**RESPONSE TO SPP REPORT NO. PPSSSH-11 (DEVELOPMENT APPLICATION NO. 19/0786)
DEMOLITION OF EXISTING STRUCTURES, CONSTRUCTION OF A MEDICAL CENTRE
398-402 KINGSWAY & 27 FLIDE STREET**

ANNEXURE A – PLANS DEMONSTRATING REQUESTED AMENDMENTS TO DEFERRED COMMENCEMENT CONDITIONS

HEALTH SERVICES FACILITY
398-402 KINGSWAY + 27 FLIDE STREET CARINGBAH NSW 2229

drawing
SOUTH WEST ELEVATION – FLIDE ST

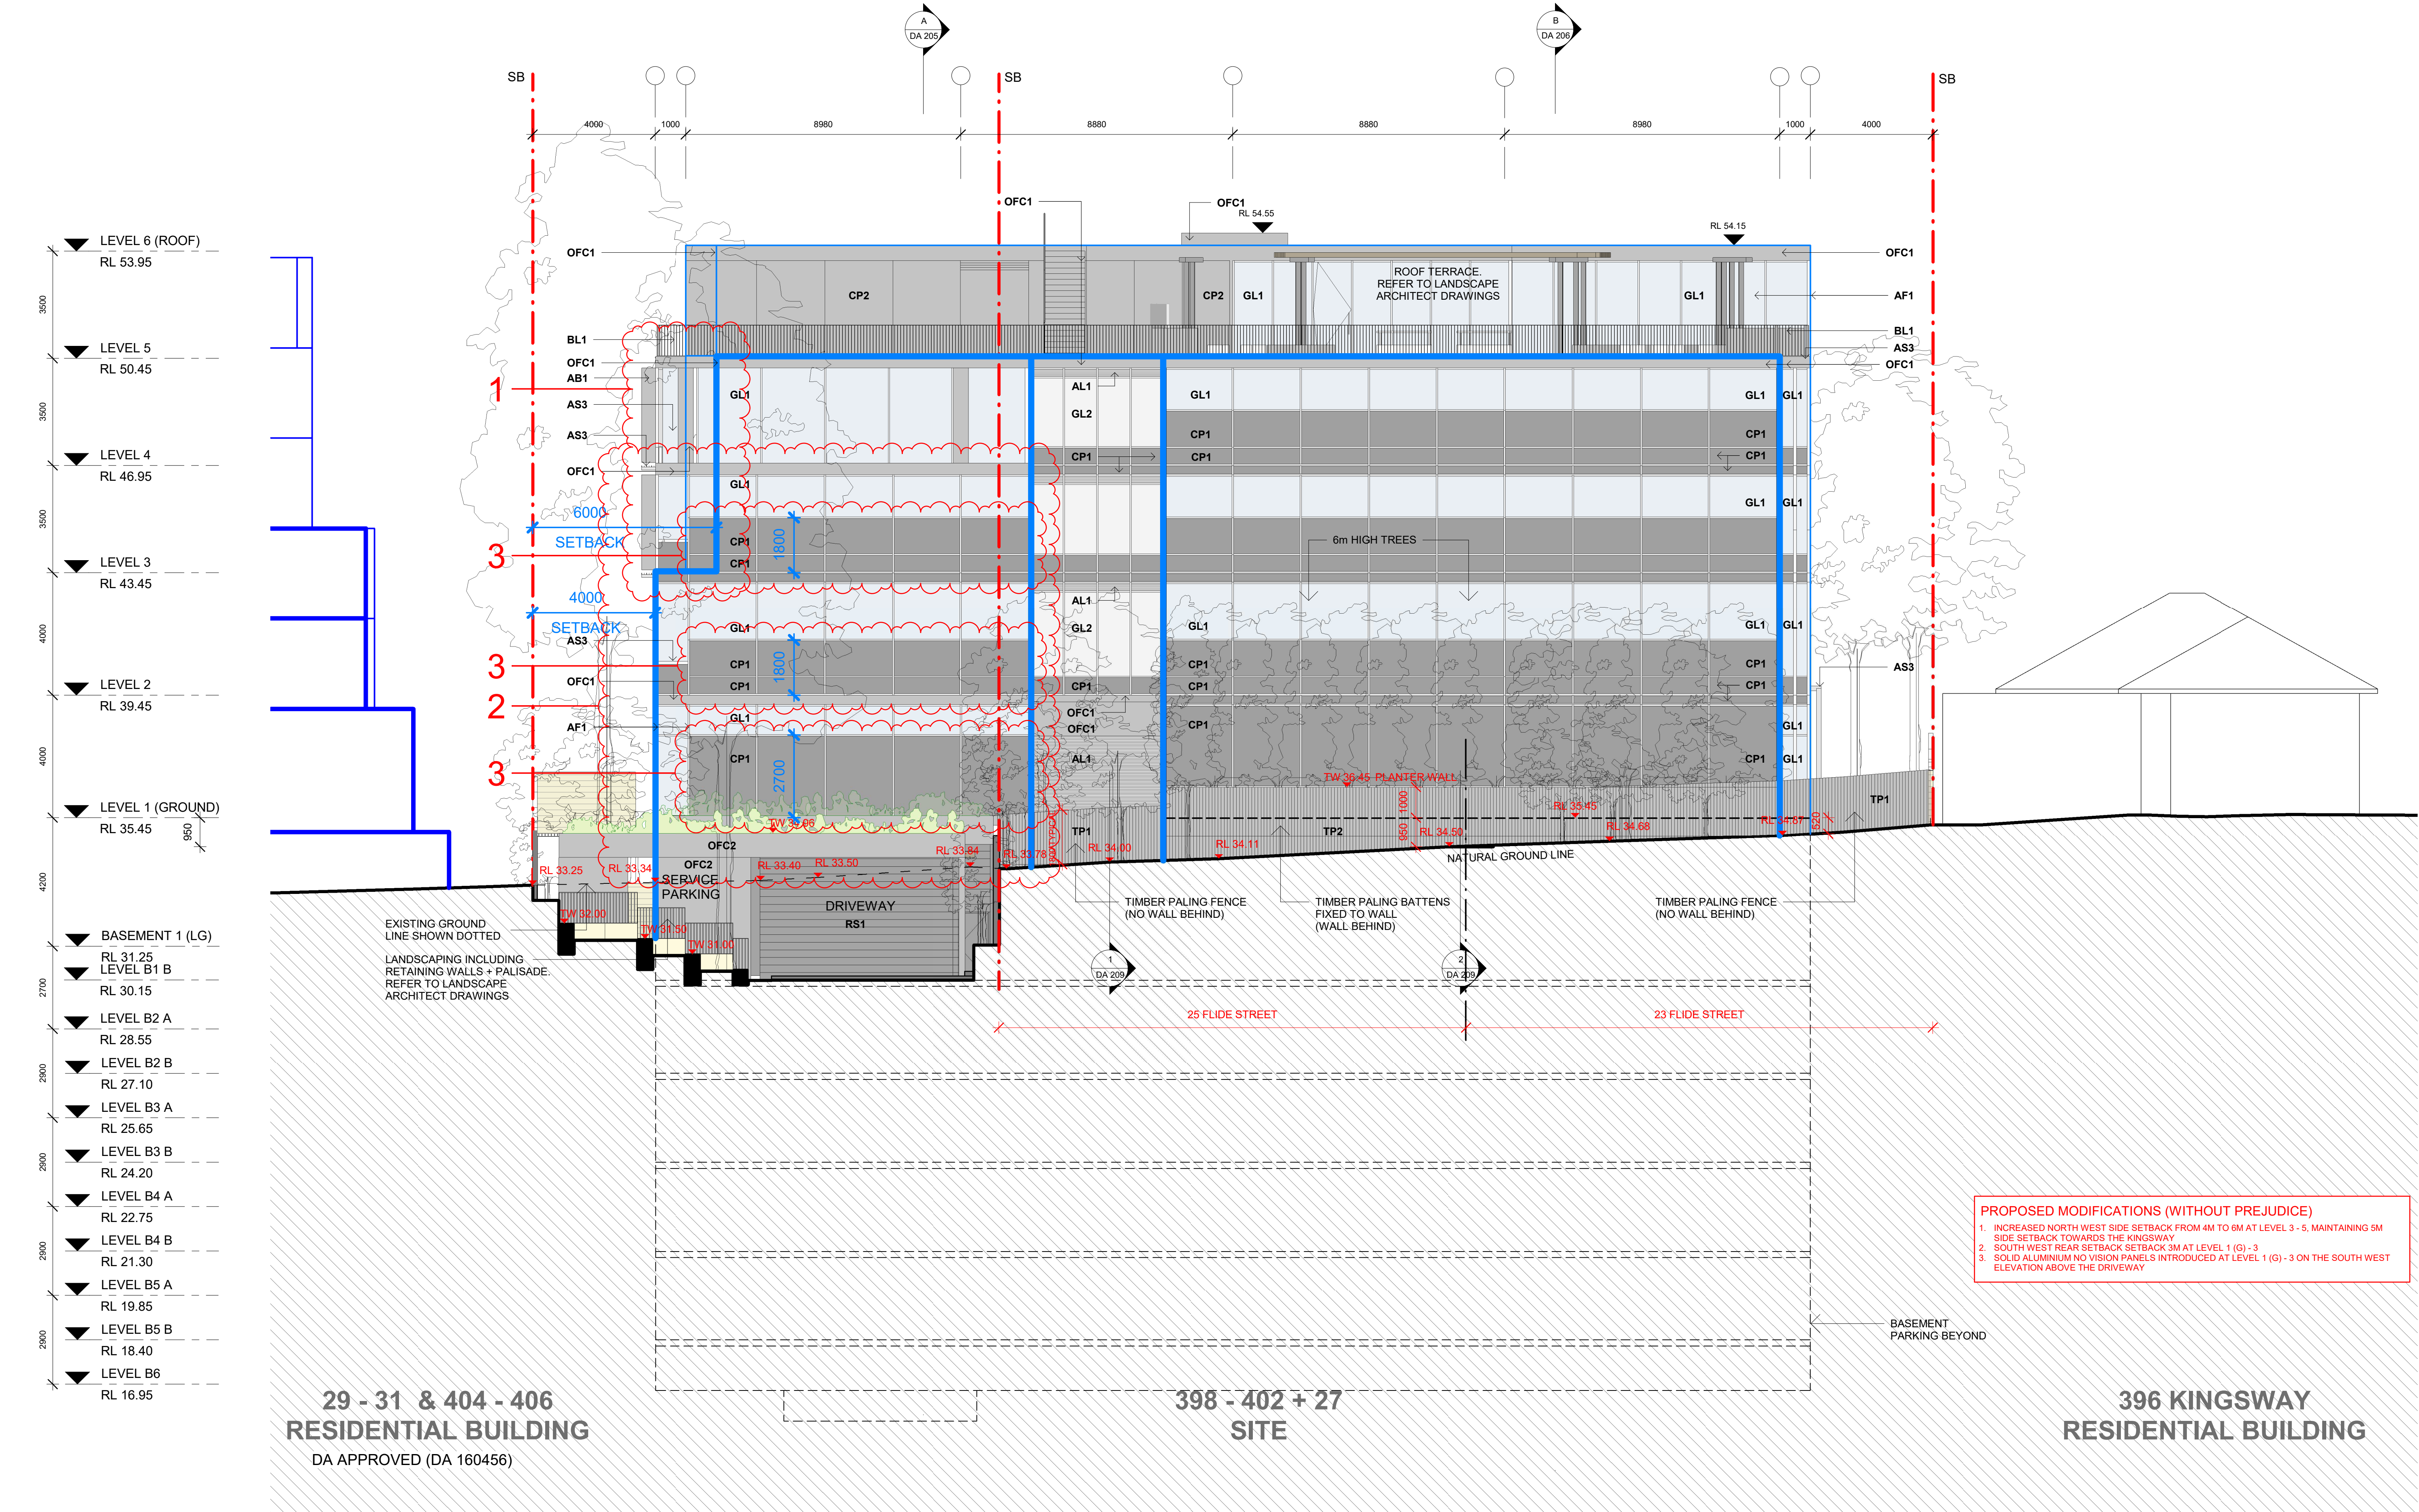
1. INCREASED NORTH WEST SIDE SETBACK FROM 4M TO 6M AT LEVEL 3 - 5, MAINTAINING 5M SIDE SETBACK TOWARDS THE KINGSWAY.
2. SOUTH WEST REAR SETBACK SETBACK 3M AT LEVEL 1 (G) - 3
3. SOLID ALUMINIUM NO VISION PANELS INTRODUCED AT LEVEL 1 (G) - 3 ON THE SOUTH WEST ELEVATION ABOVE THE DRIVEWAY

Figure 1: Illustration showing one possible scenario with one third of façade as articulation zone.

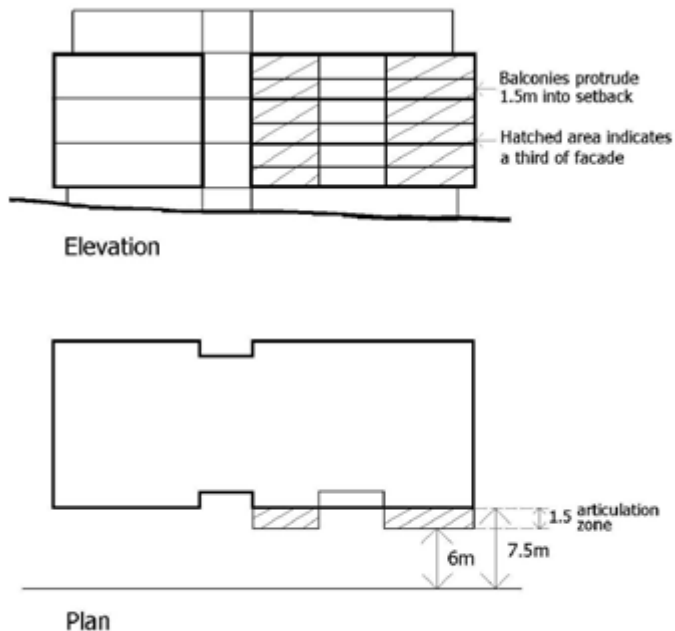
The DCP permits an encroachment in to the front setback zone by 1.5m for 1/3 of the area of the front façade which is illustrated in Figure 1: Illustration showing one possible scenario with one third of the façade as articulation zone.
